Re: Calpine Geysers Units 3, 16, 17, 18, 19, and 20 License Amendments

Calpine Geyser's Units 3, 16, 17, 18, 19, and 20 Amendments

Prepared for
Calpine

June 18, 2003

FIGURE 2A

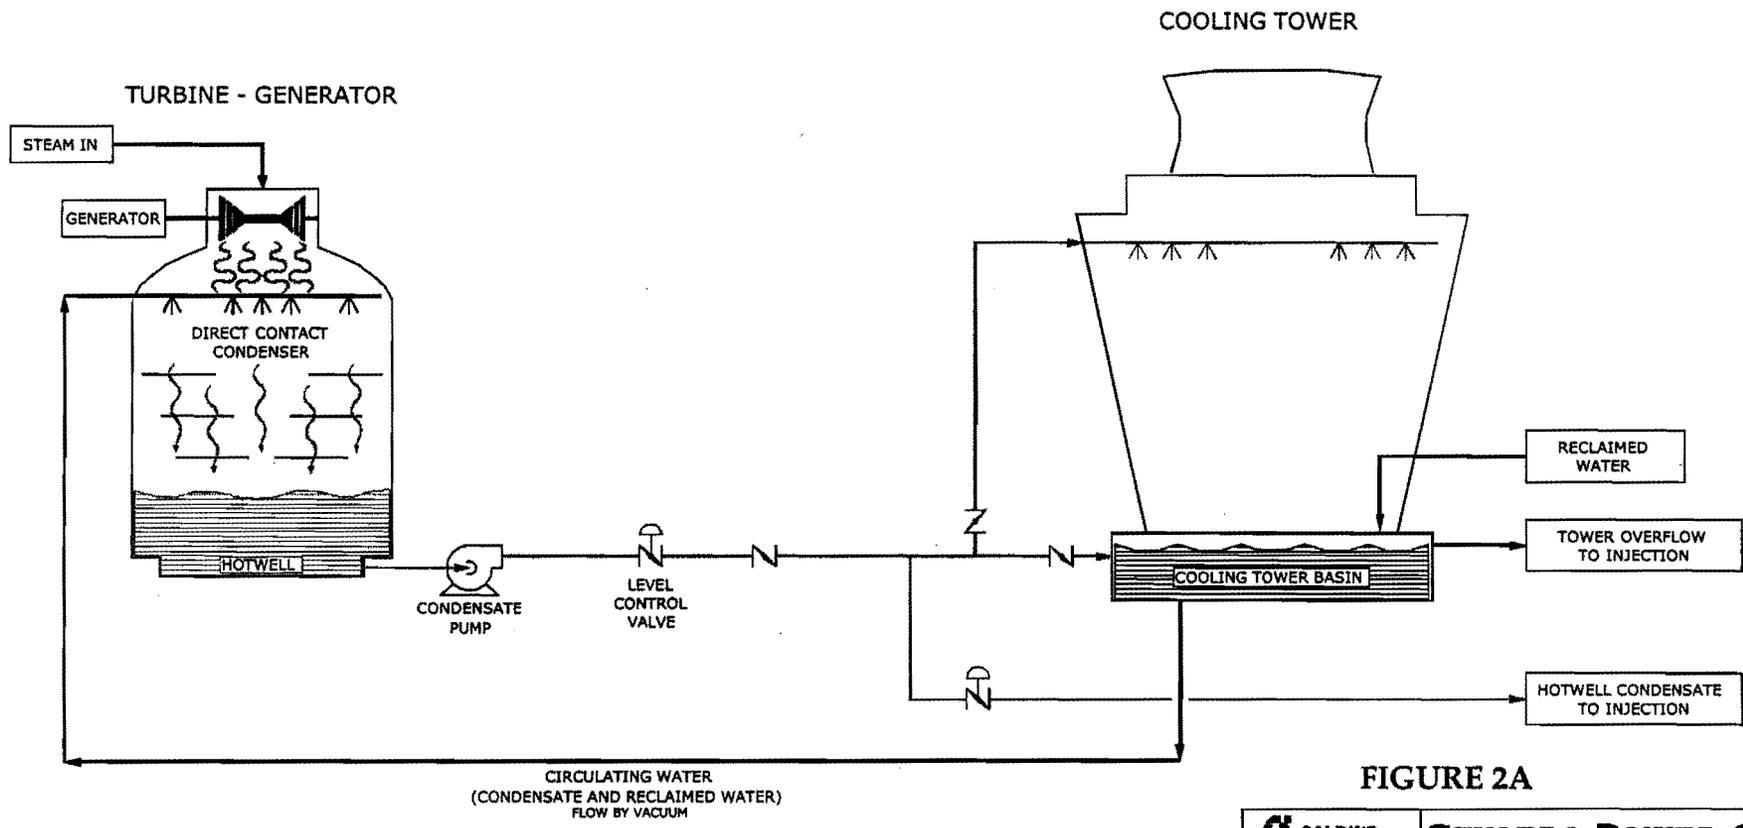
Figure 2A and 2B present simplified process flow diagrams for the cooling tower circulating water systems for the six CEC-licensed facilities. Figures 3 through 8 present plot plans that show the extent of the pipeline modifications at Units 3, 16, 17, 18, 19, and 20. Calpine is in the process of obtaining Title 22 Permits from the State Department of Health Services, any necessary Waste Discharge Requirements Permits from the Regional Water Quality Control Boards, and injection approvals from the California Division of Oil, Gas and Geothermal Resources (DOGGR).

Figure 3

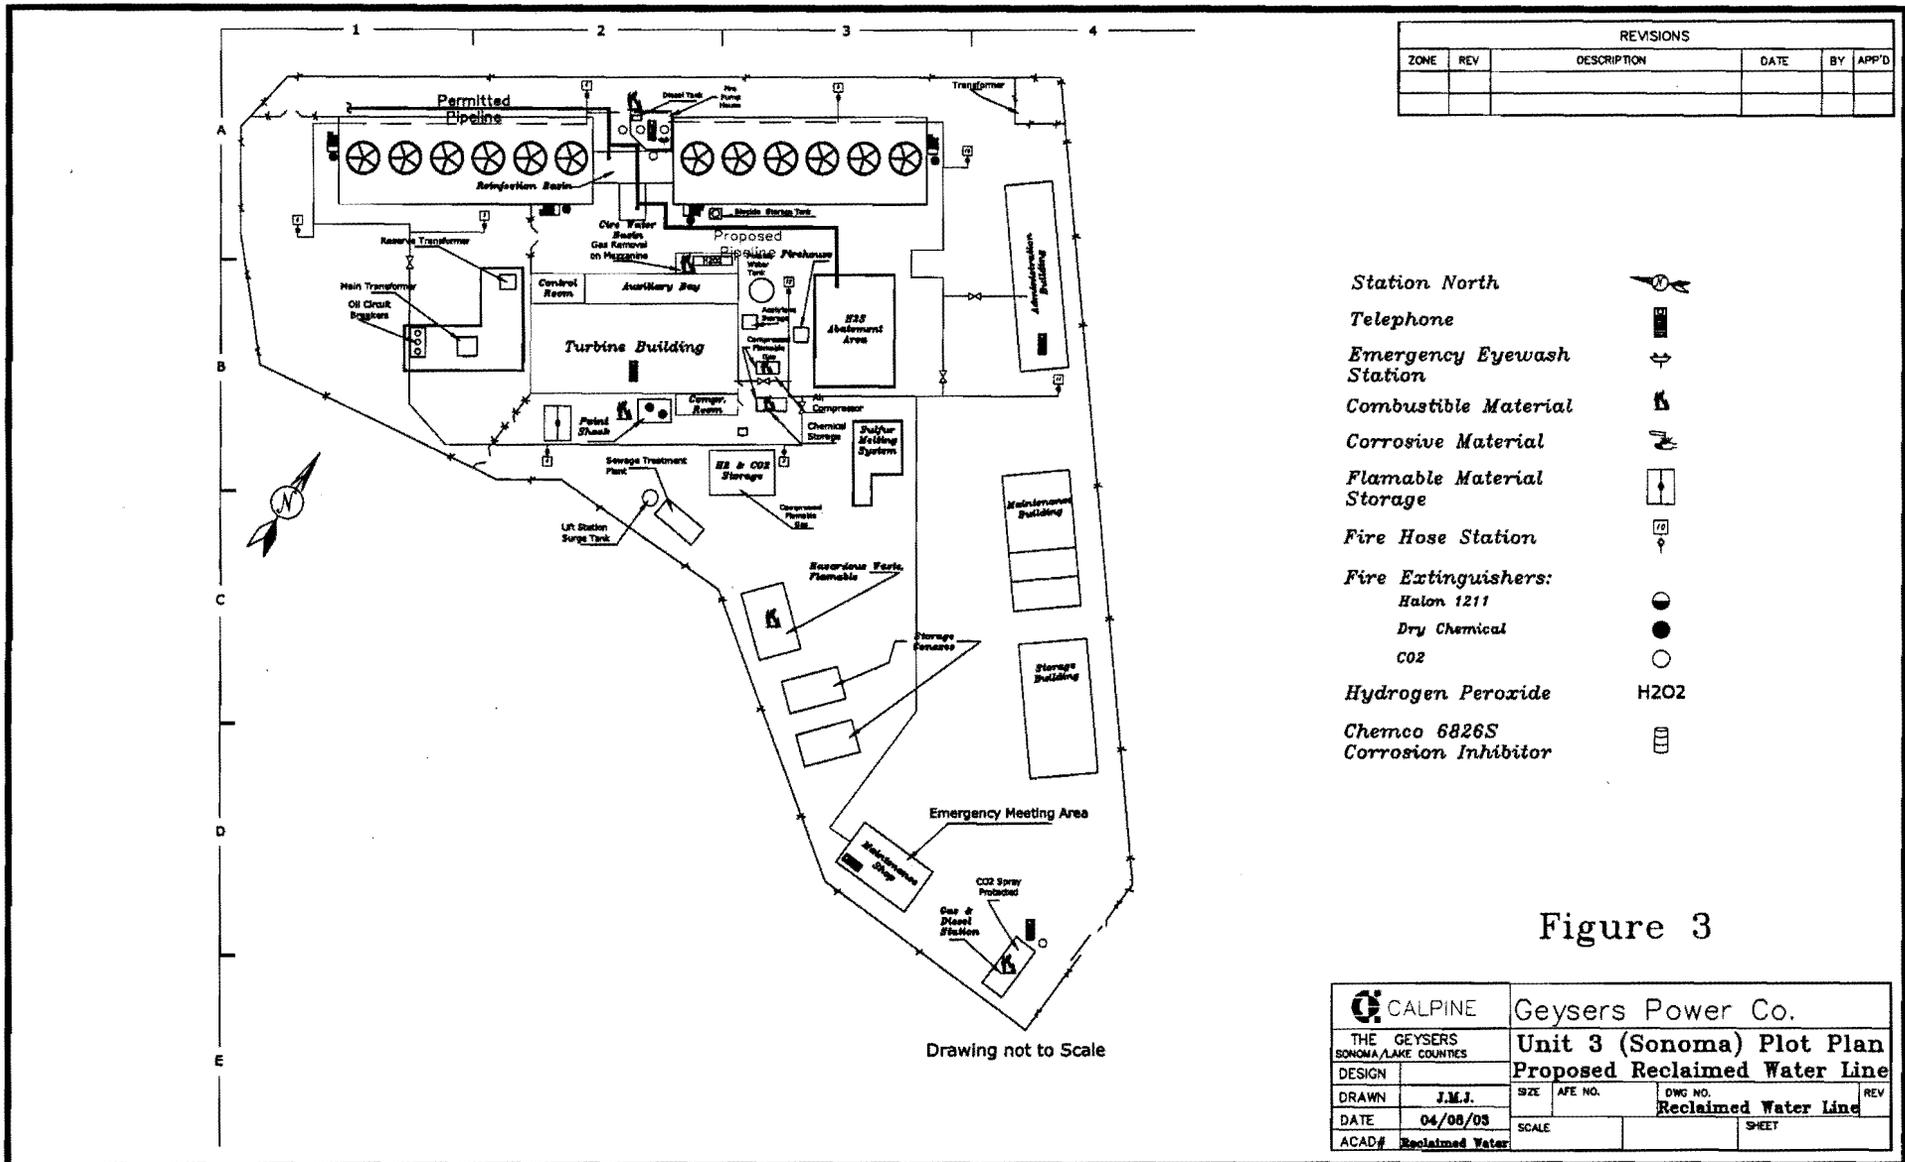
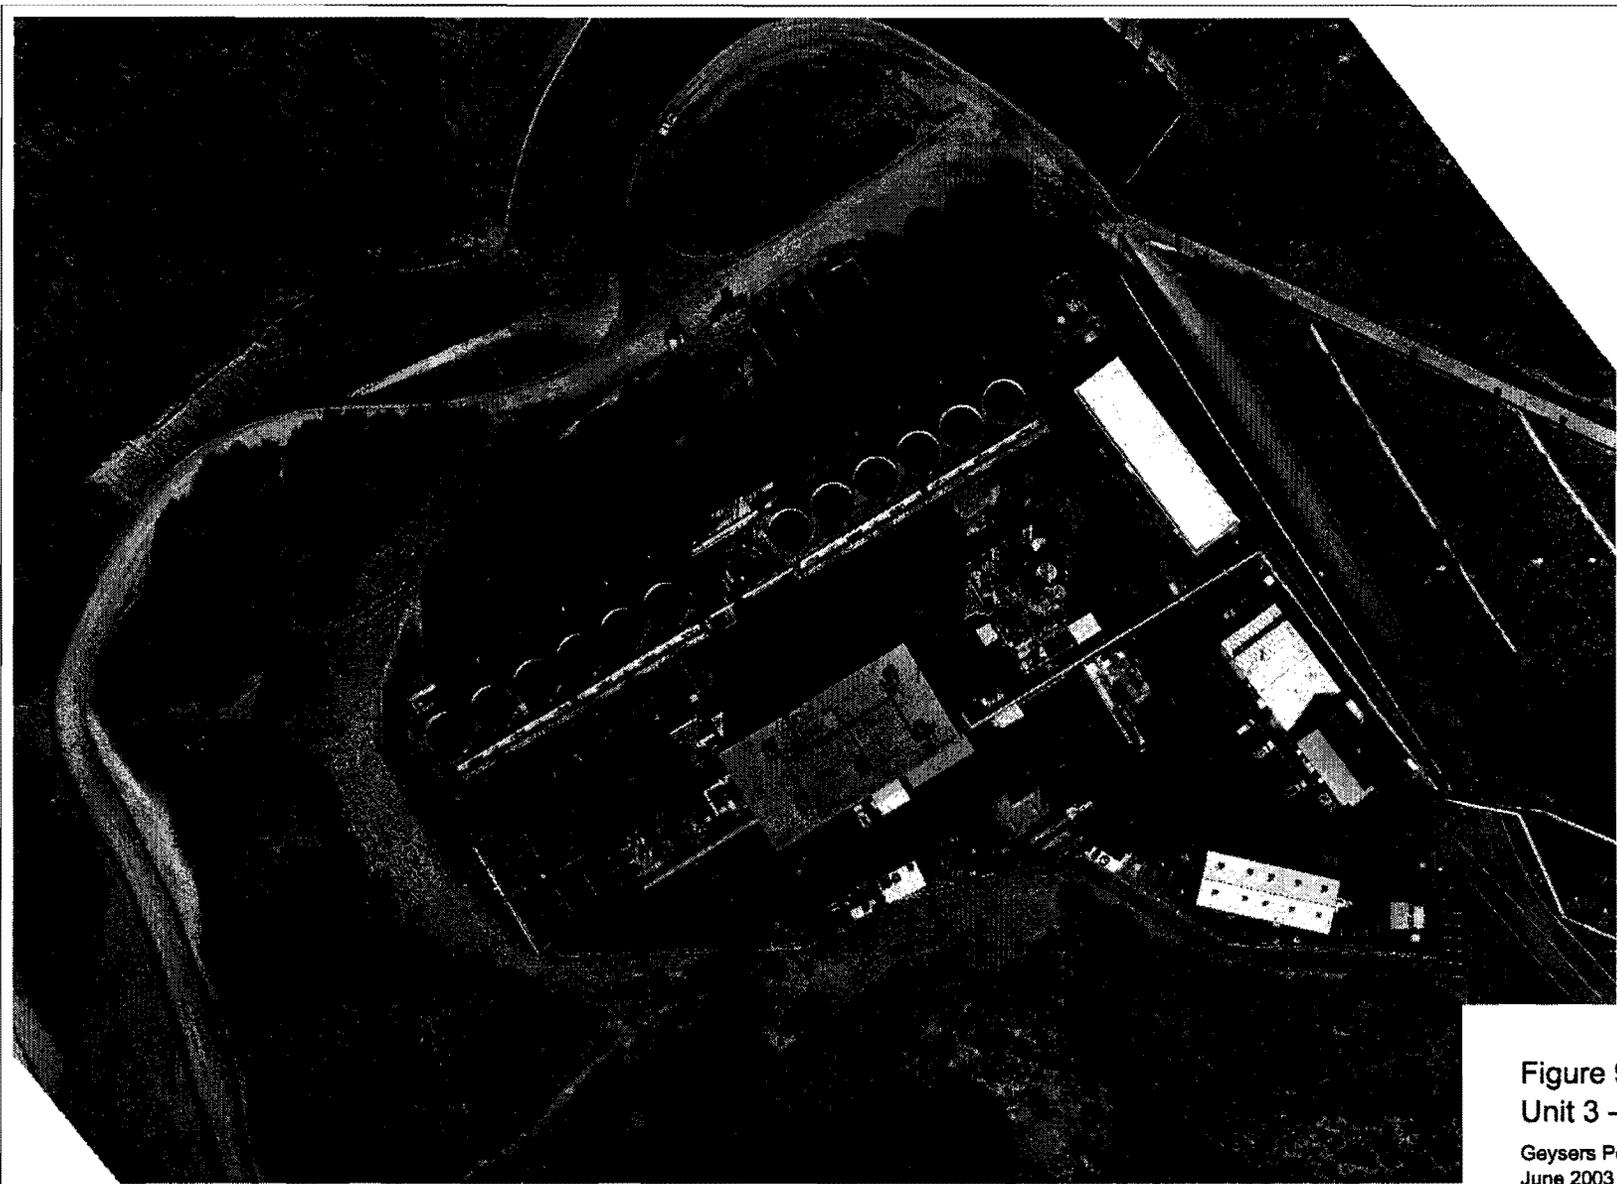
As shown in Figures 3 and 9, the recycled water supply pipeline is already onsite and no ground disturbance is required on this Unit. Therefore, no additional construction will be required and no impacts to cultural resources are expected.

Figure 4

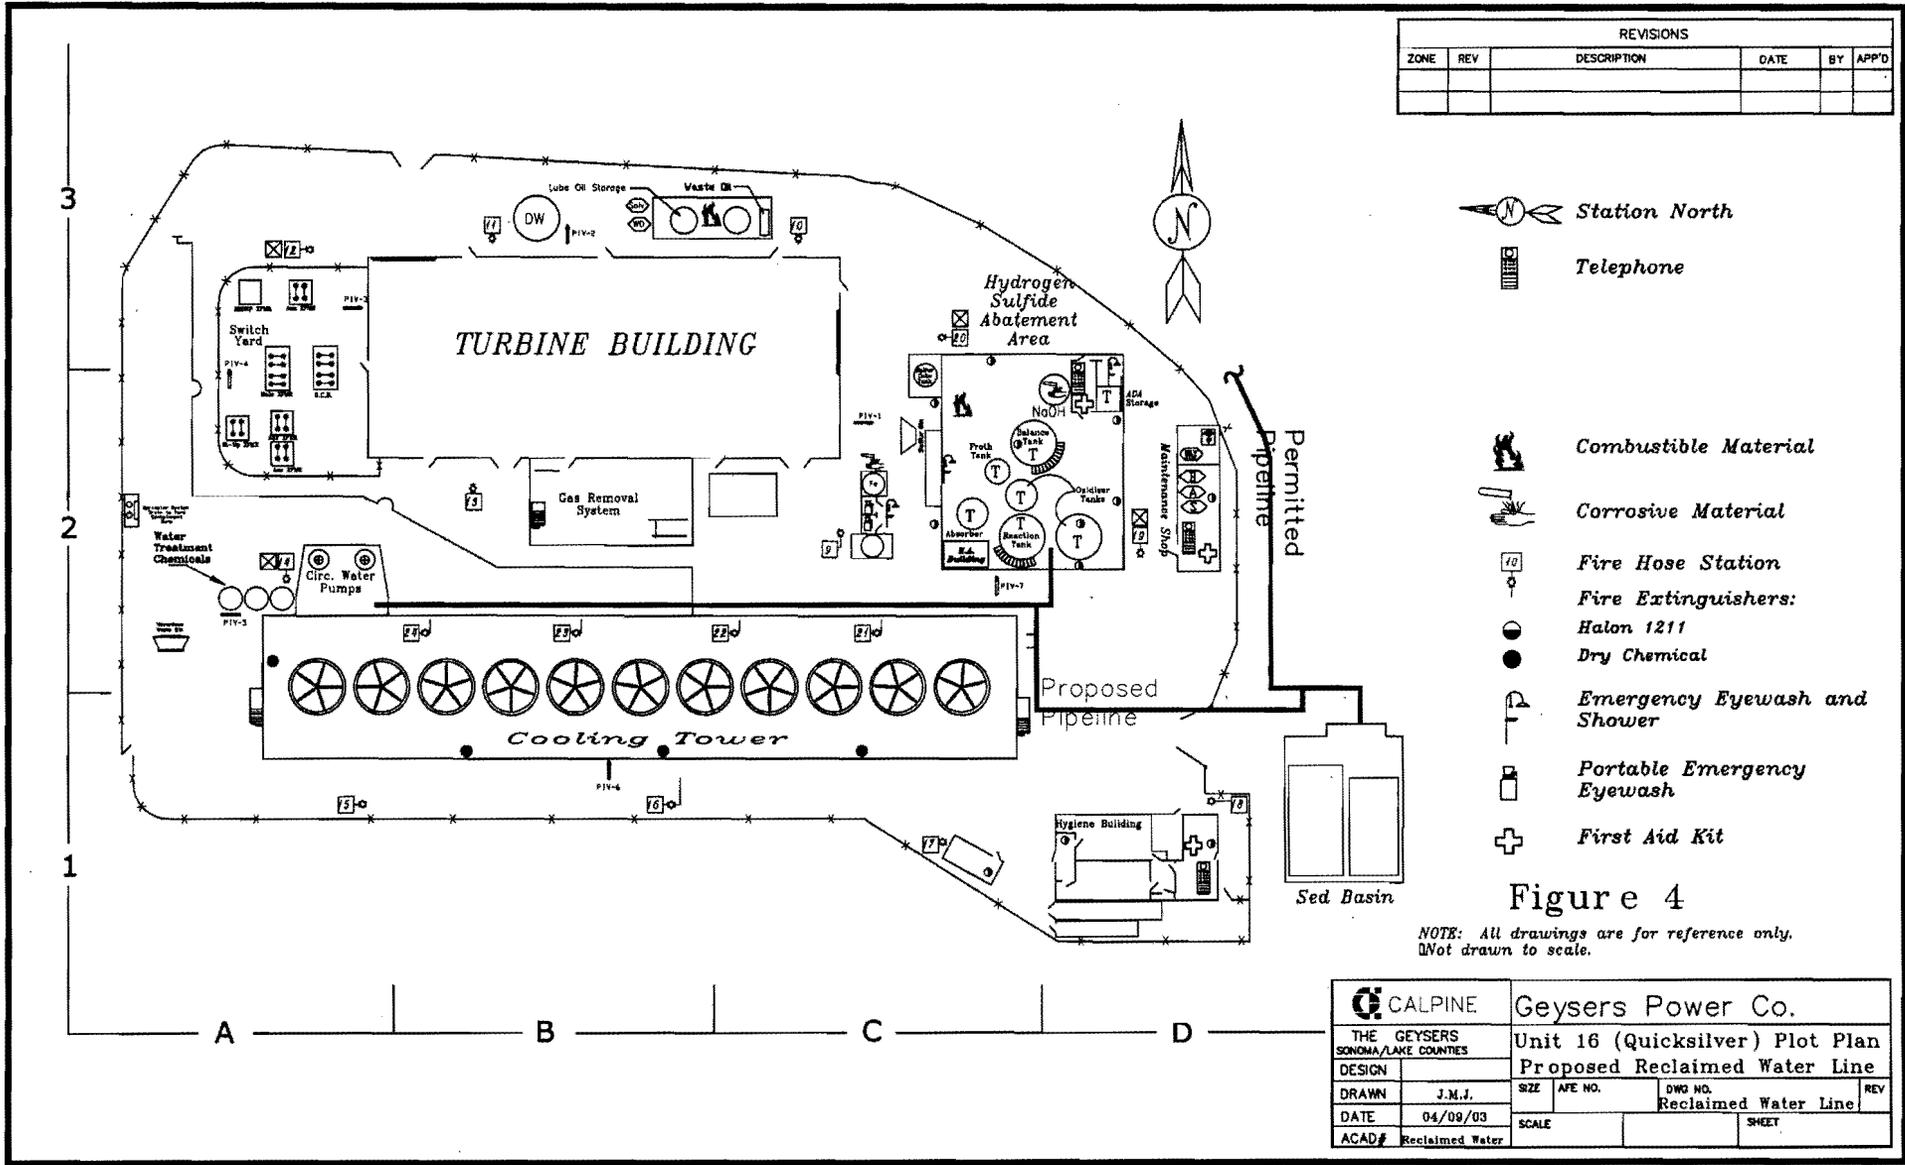
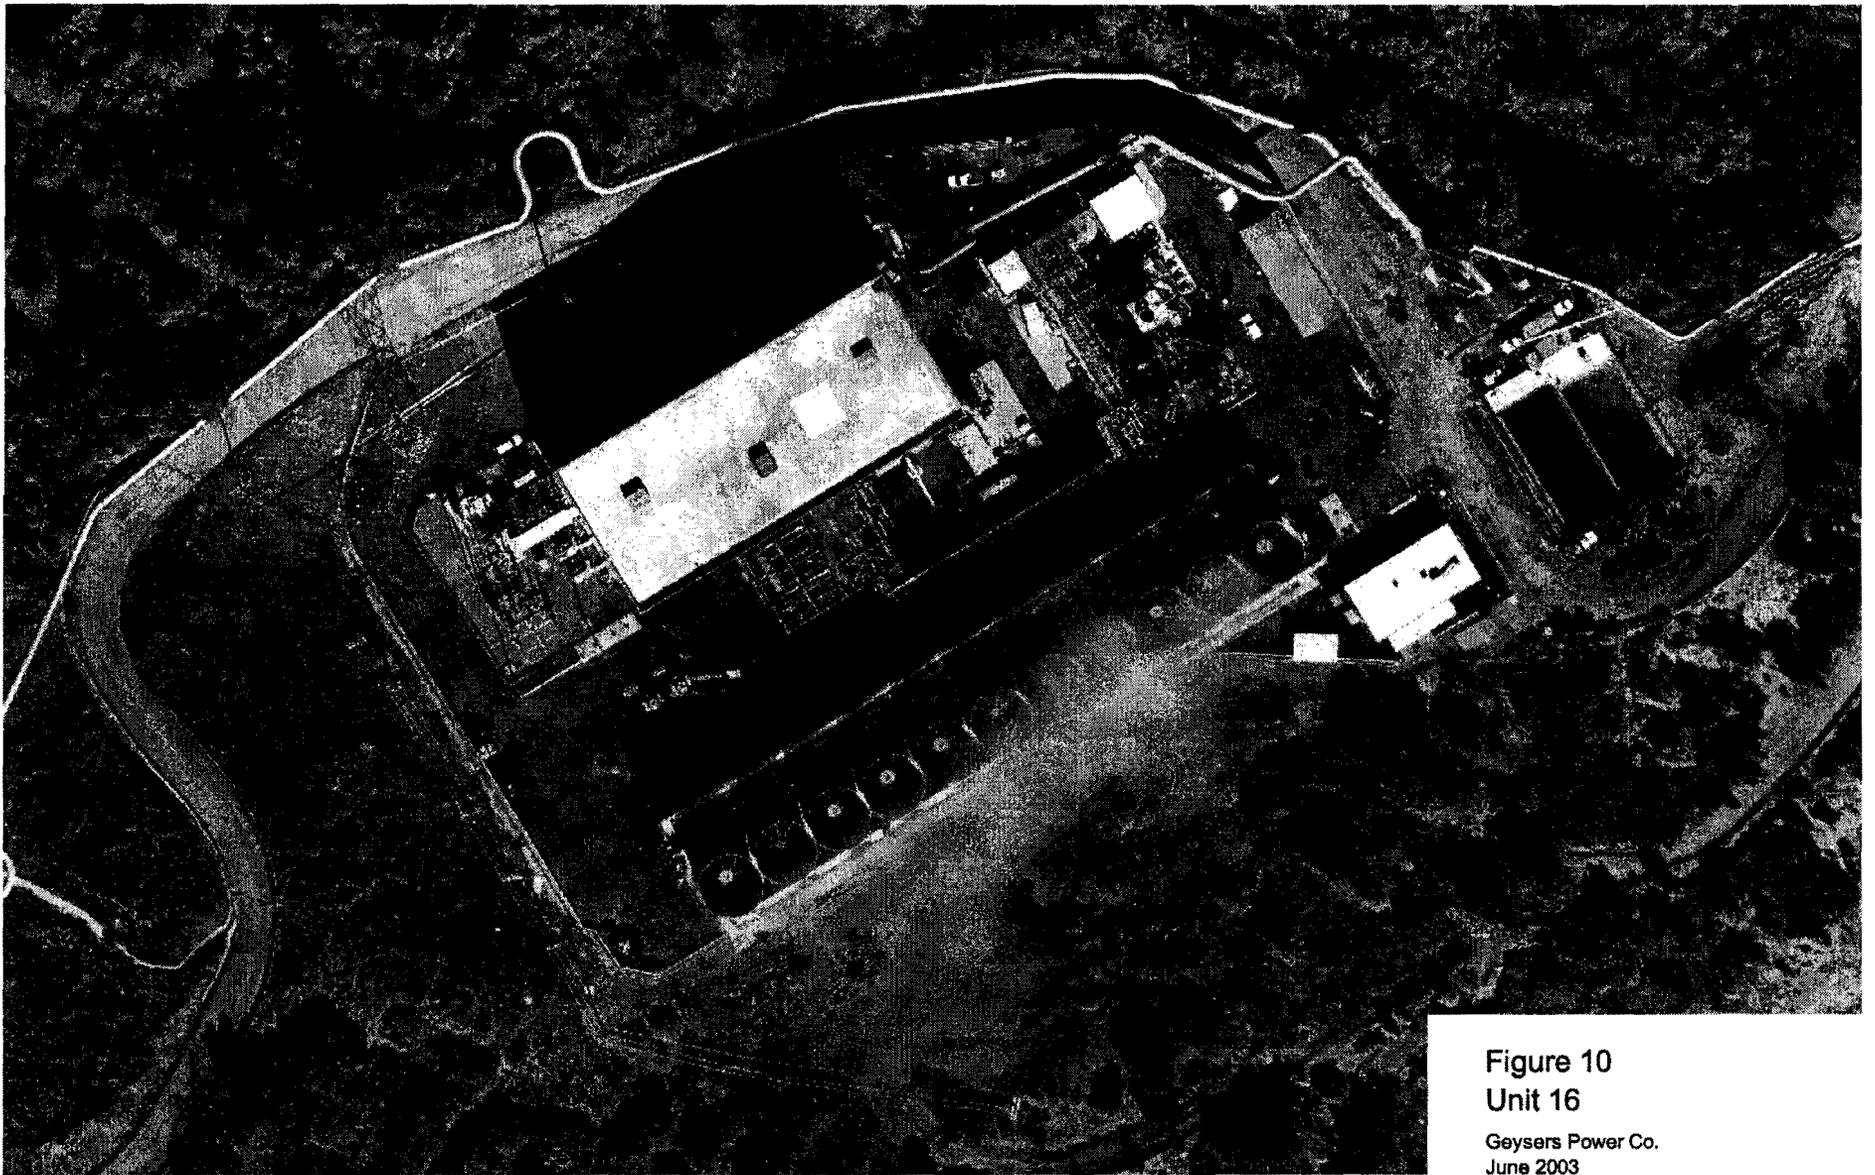
As shown in Figures 4 and 10, the proposed recycle water supply pipeline route is located in the existing access road. The construction of this pipeline will be by open trenching to a depth of 3 feet in soils previously disturbed during construction of Unit 16. Therefore, no cultural resource impacts are expected.
